**Santa Margarita River
Flood Control Project
MILCON Project P-010**

**Basilone Road Bridge
Replacement
MILCON Project P-030**

**Section 404 Clean Water Act
Draft 404 (b) (1) Analysis and
Public Interest Review for
MILCON Projects P-010
and P-030**

**FINAL
ENVIRONMENTAL IMPACT STATEMENT**

Figure 2.3-1

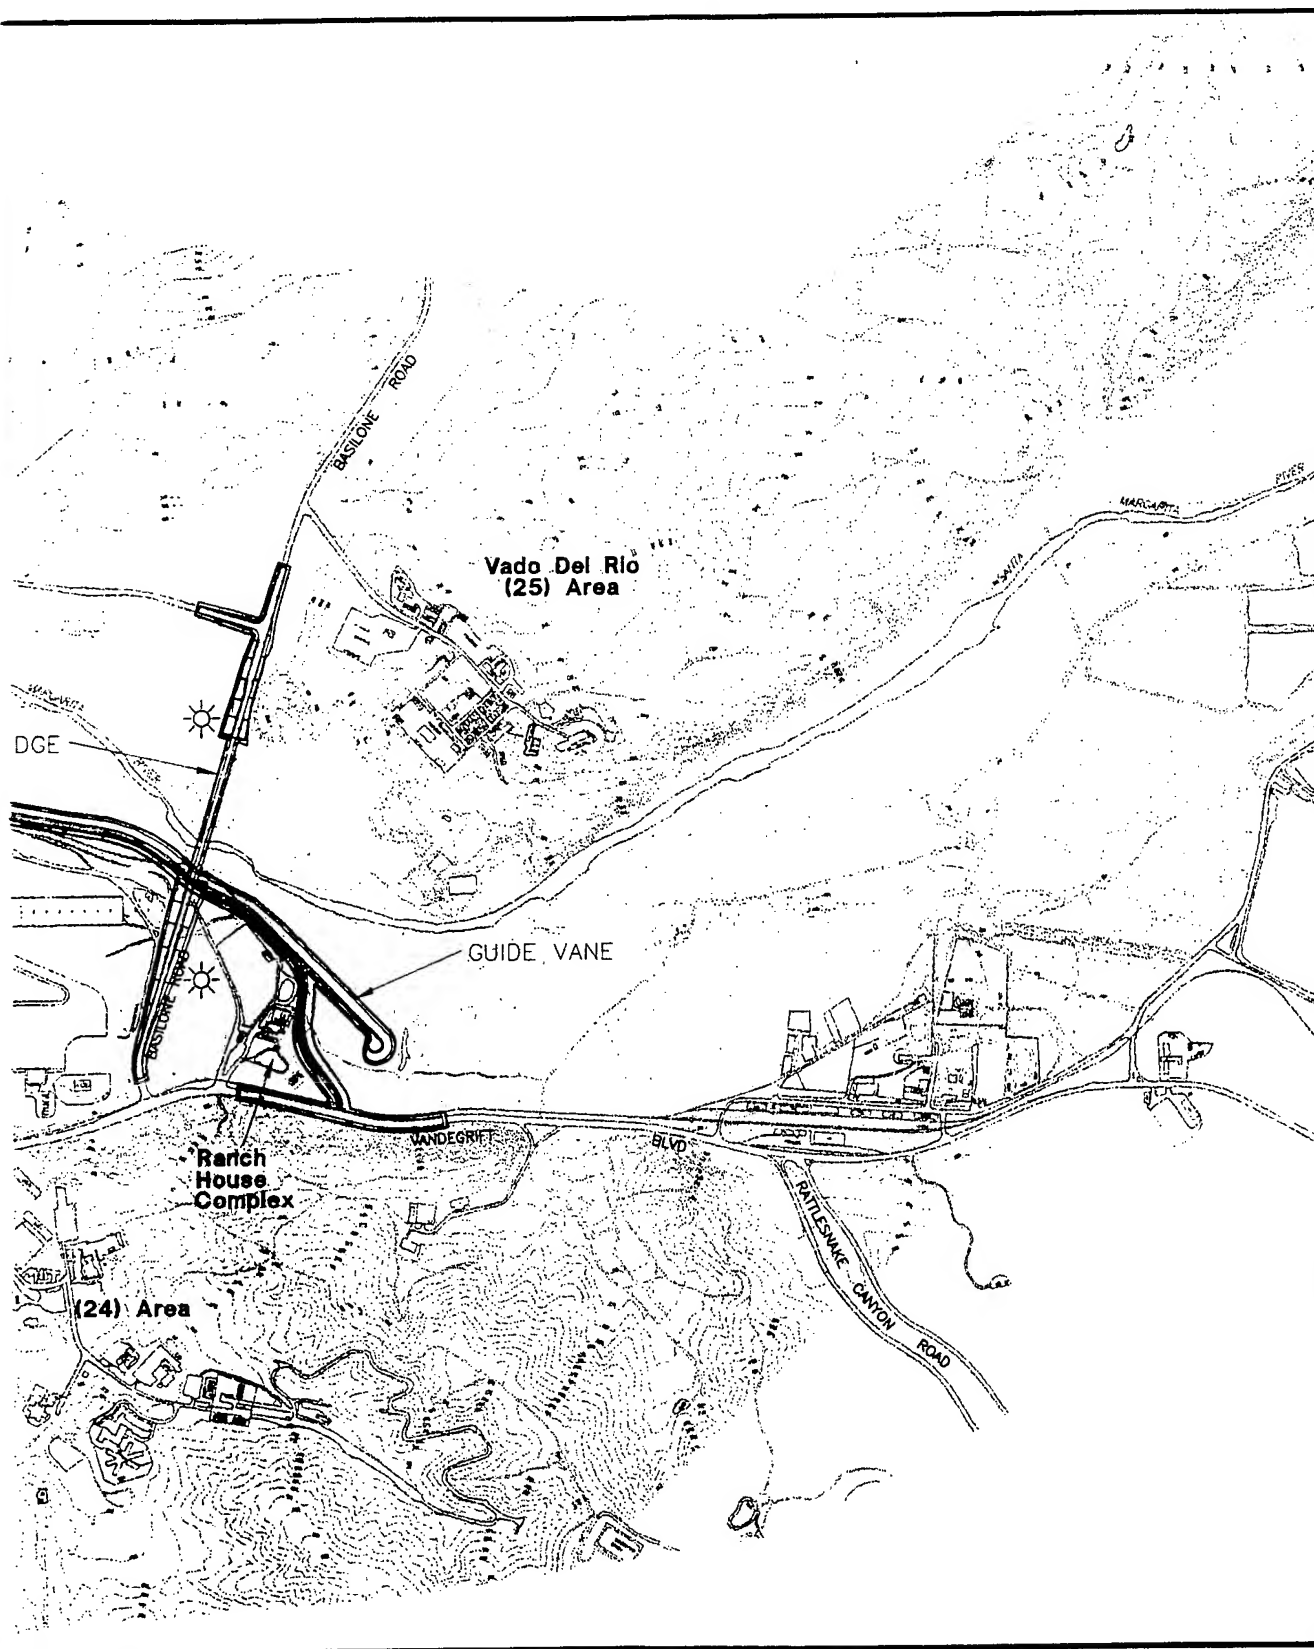
3.16	16	2-5	Fig 2.3-1	SPECIFIC COMMENTS Section 2.0 Proposed Action and Alternatives, 2.3 Alternatives to Implement the Proposed Action, Figure 2.3-1 "Alternative 3A-Preferred Alternative", Pg. 2-5. Since the storm water management system is a component of Alternative 3A, the FEIS should indicate the location of the existing earthen ditch, proposed pump station, and discharge point on this figure.	Comment noted. Figure 2.3-3 on page 2-9 provides an illustration of the existing earthen ditch with reference to the floodwall. Figure 2.3-4 is a detailed drawing of a plan view of the proposed pump station that includes identification of the outlet portion of that structure.

Section 2.0 Proposed Action and Alternatives, 2.3 Alternatives to Implement the Proposed Action, Figure 2.3-1 "Alternative 3A-Preferred Alternative", Pg. 2-5 Since the storm water management system is a component of Alternative 3A, the FEIS should indicate the location of the existing earthen ditch, proposed pump station, and discharge point on this figure.

Figure 3.3 - 2

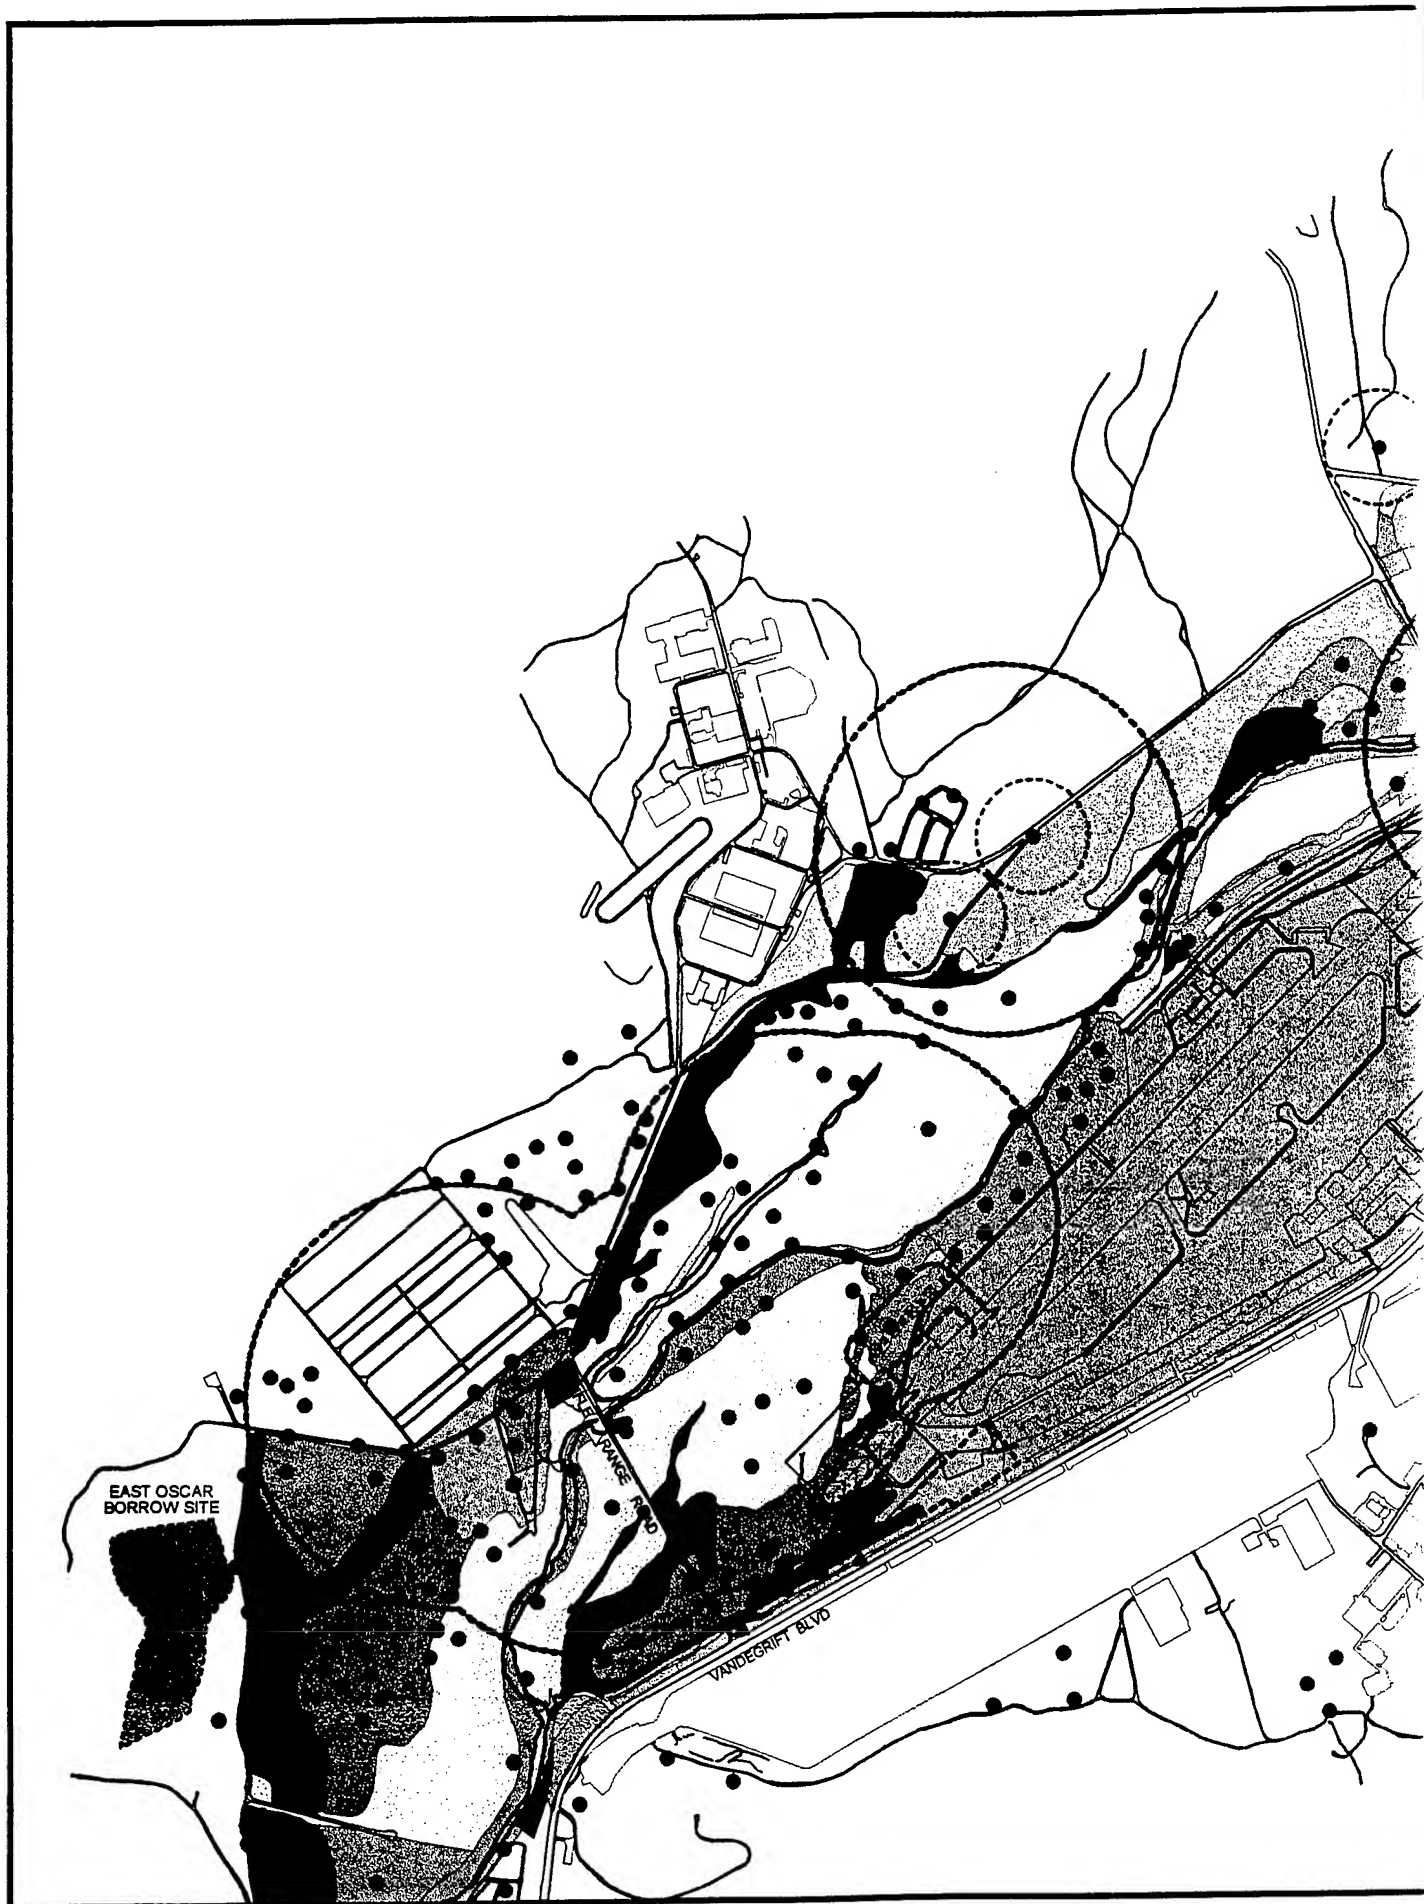
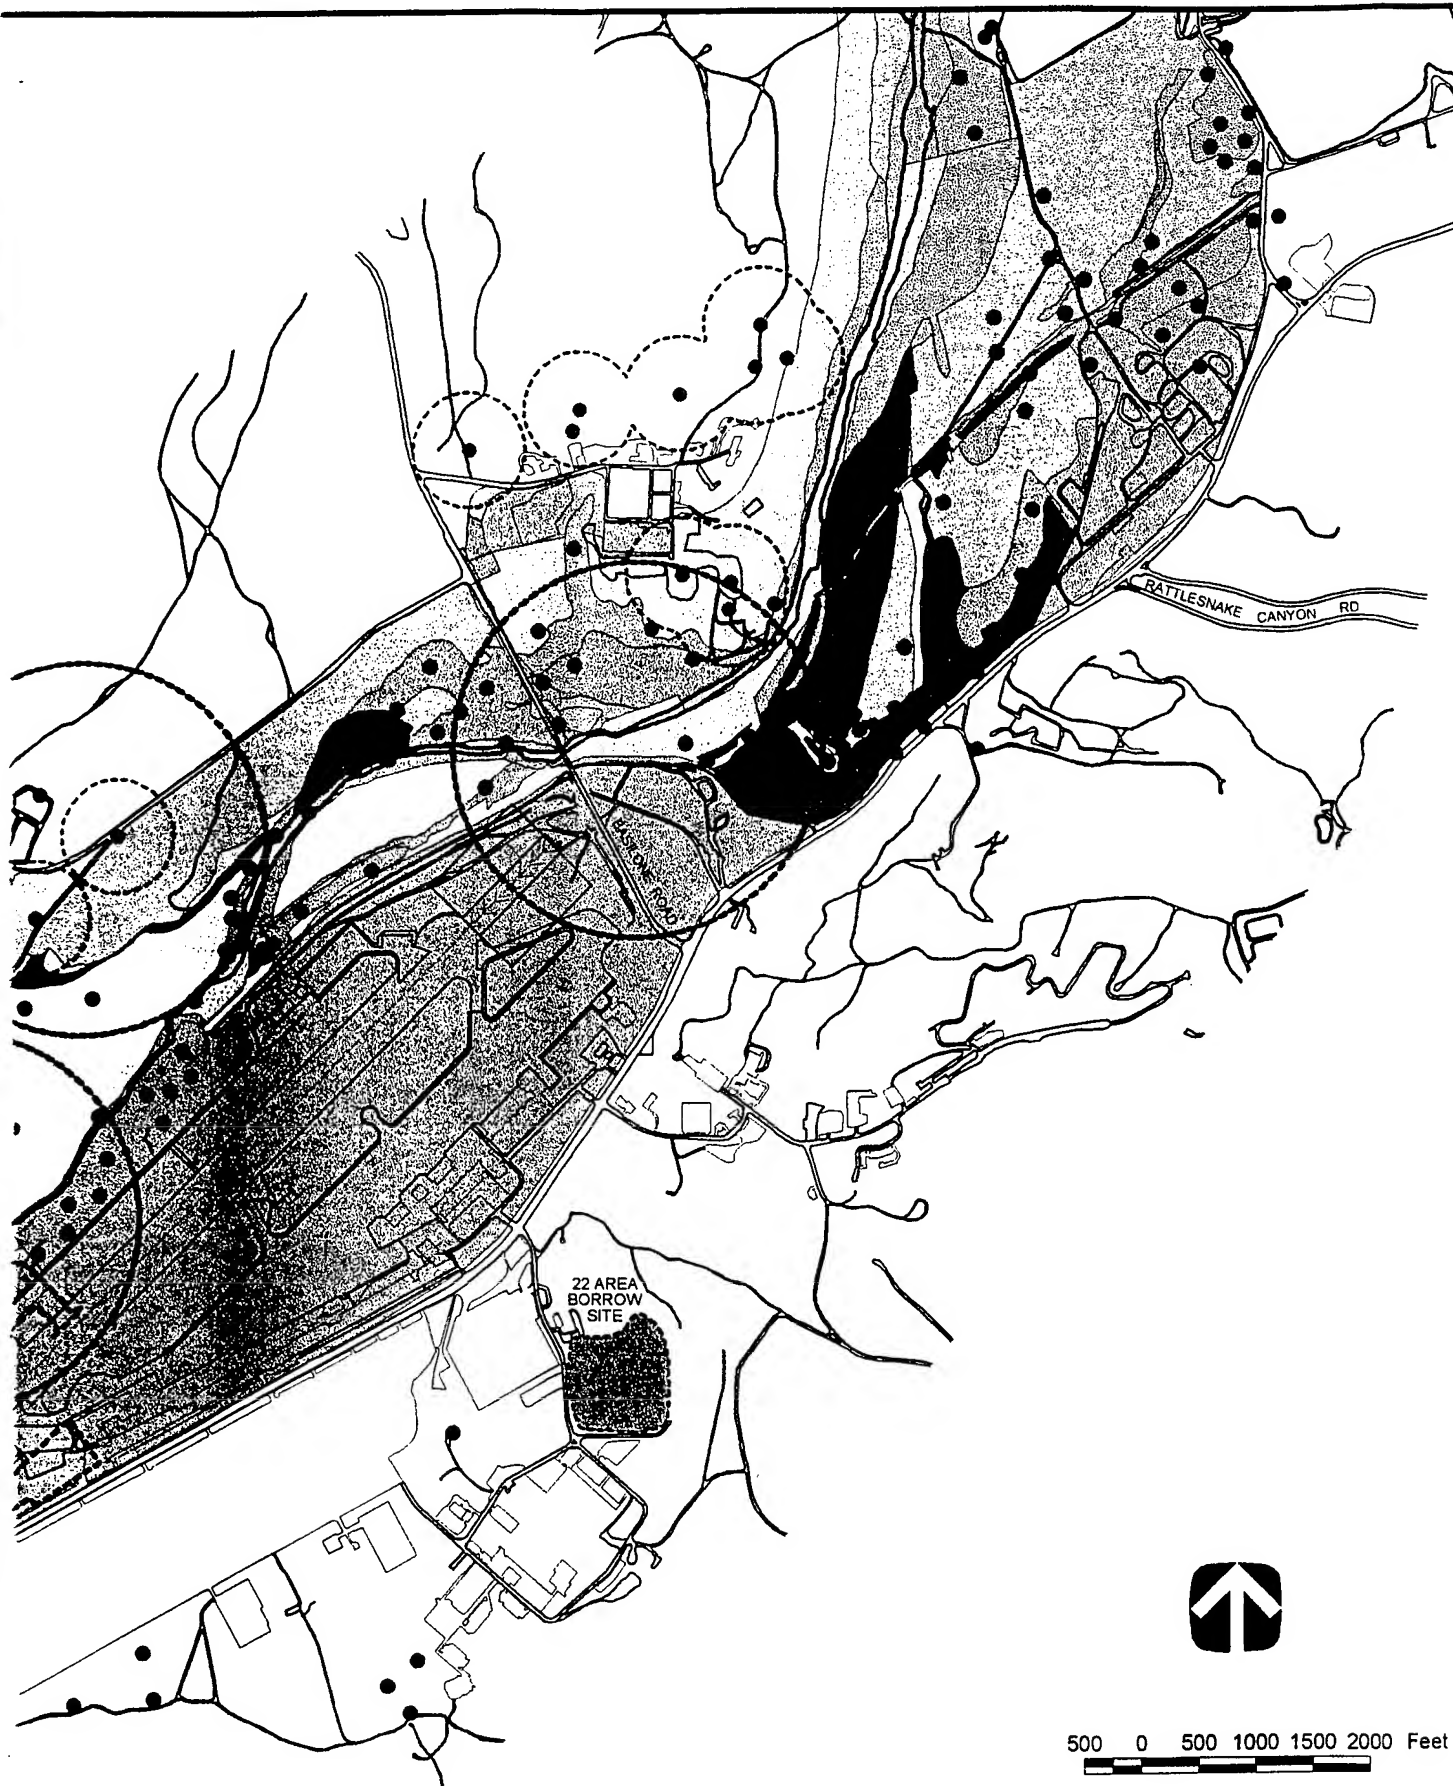
3.08	8	3.3-9	Fig 3.3-2	According to the DEIS, the preferred alternative levee/floodwall alignment footprint would occur primarily within areas designated as grass-forb and Arundo. However, based on the Service's review of 1994 aerial photographs, Status Report 2, and the location of federally listed species as shown in Figure 3.3-2 "Sensitive Species", there appears to be a discrepancy regarding the habitat communities found within the project area. For instance, three Flycatcher locations are identified within an area mapped as grass-forb (Figure 3.3-2). However, Status Report 2 and a review of 1994 aerial photographs indicate this area riparian woodland.	Comment noted. Figure 3.3-2 "Sensitive Species" has been revised to provide greater detail of habitat communities.

3.20	20	3.3-9	Fig 3.3-2	Section 3.0, Affected Environment, 3.3 Biological Resources, 3.3.3 Figure 3.3-2 "Sensitive Species", Pg. 3.3-9. Survey information regarding the occurrence of the California gnatcatcher within the area influenced by the proposed action should be included on this figure in the FEIS.	Comment noted.. A 1994 survey did not identify any California Gnatcatchers within the areas of influence of the proposed project. Only one Gnatcatcher was been found and it was outside the project area. As a result, no adverse impacts to this species would occur. The location of the individuals discovered during the survey is not shown on Figure 3.3-2 due to its scale.

According to the DEIS, the preferred alternative levee/floodwall alignment footprint would occur primarily within areas designated as grass-forb and Arundo. However, based on the Service's review of 1994 aerial photographs, Status Report 2, and the location of federally listed species as shown in Figure 3.3-2 "Sensitive Species", there appears to be a discrepancy regarding the habitat communities found within the project area. For instance, three Flycatcher locations are identified within an area mapped as grass-forb (Figure 3.3-2). However, Status Report 2 and a review of 1994 aerial photographs indicate this area as riparian woodland.

Section 3.0 Affected Environment, 3.3 Biological Resources, 3.3.3 Figure 3.3-2 "Sensitive Species", Pg. 3.3-9 Survey information regarding the occurrence of the California gnatcatcher within the area influenced by the proposed action should be included on this figure in the FEIS.

Figure 3.10-2

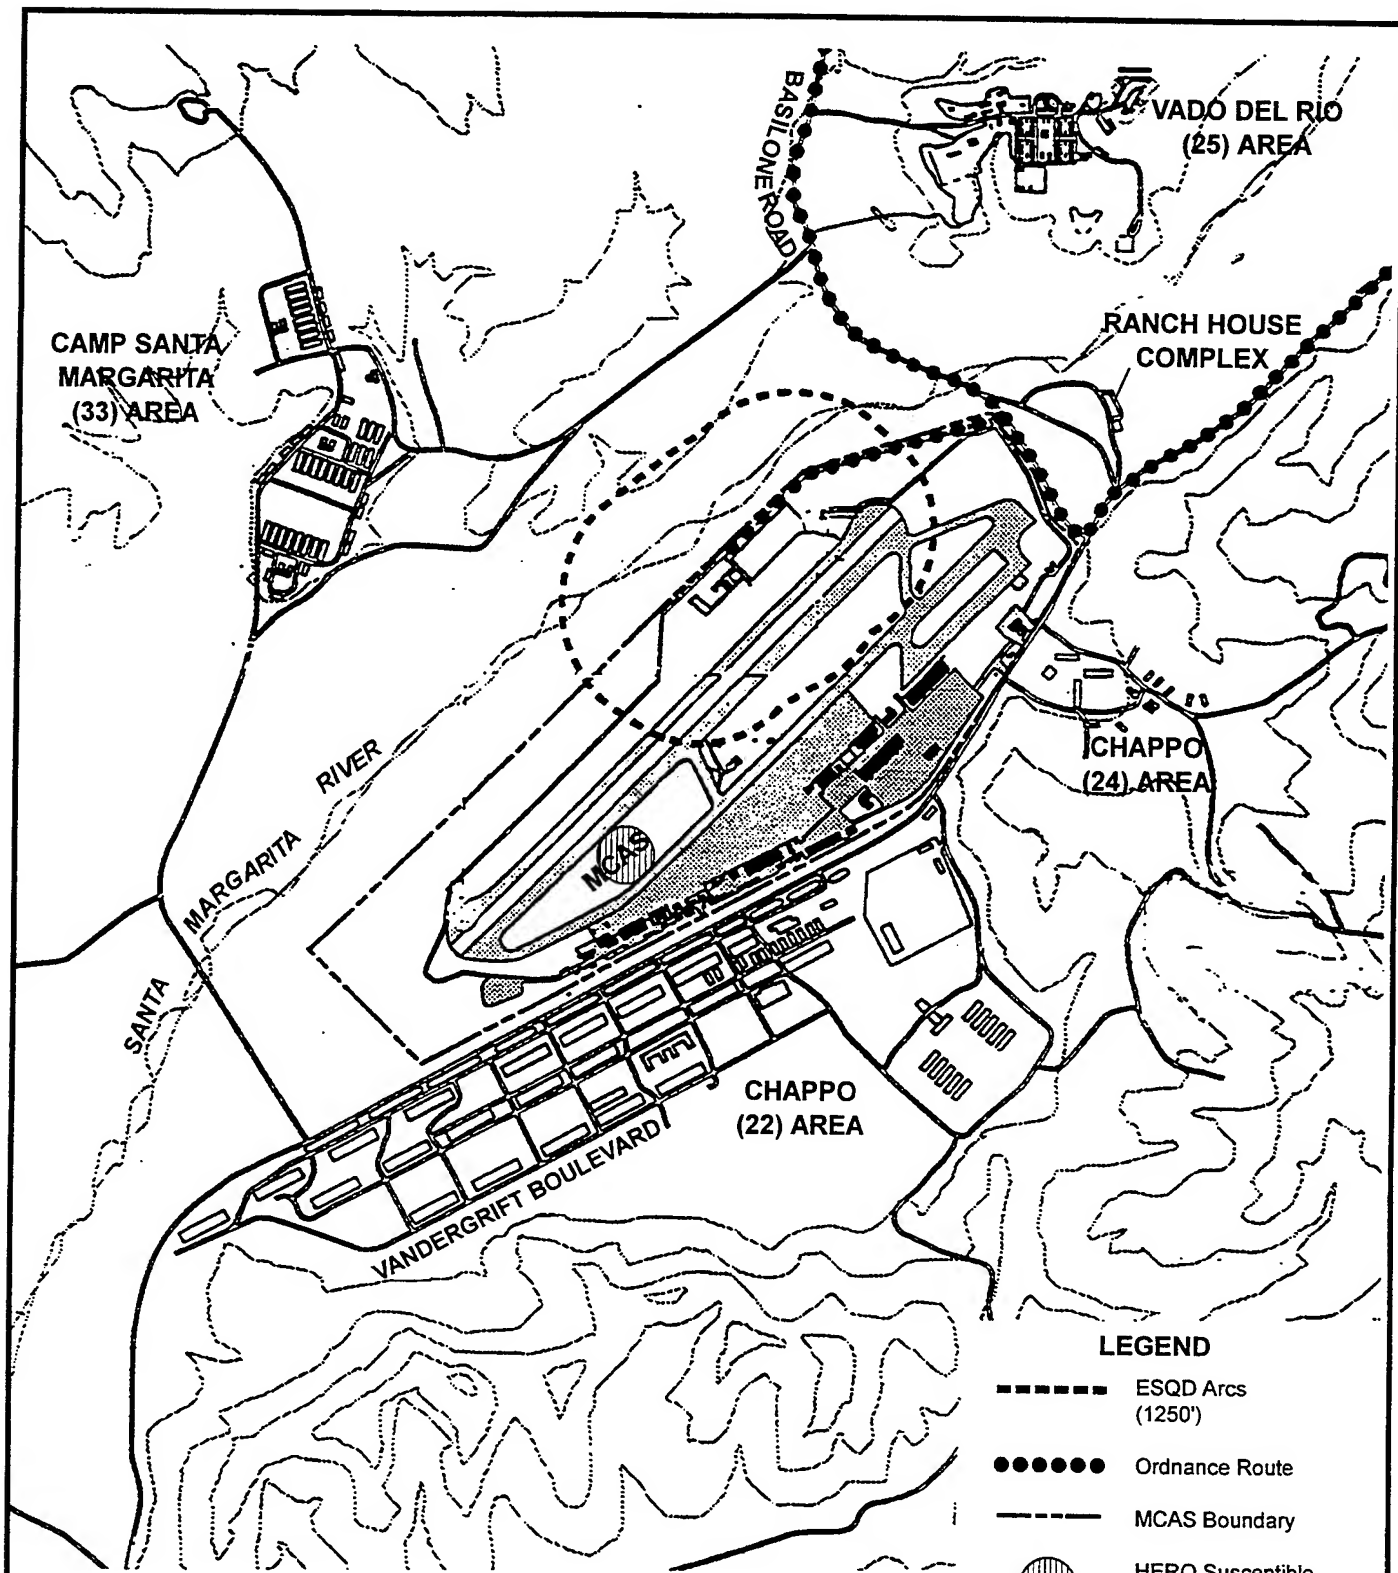
6.30	17	4-10.7	4.10.4	17. Section 4.10.4. Worker safety as it pertains to explosive safety has not been addressed. Section 3.10.3, Figure 3.10-2 shows that a significant portion of the Project levee falls within the ESQD. Since it is stated that a minimum separation from explosives handling and storage applies to public traffic routes and inhabited buildings, it would appear that there would be a risk of exposing the construction workers to potential hazards from an explosion. HERO restrictions, if any, on the use of radio transmitters by construction workers should be defined.	Comments noted. A discussion of worker safety in the ESQD has been added to Section 4.10.
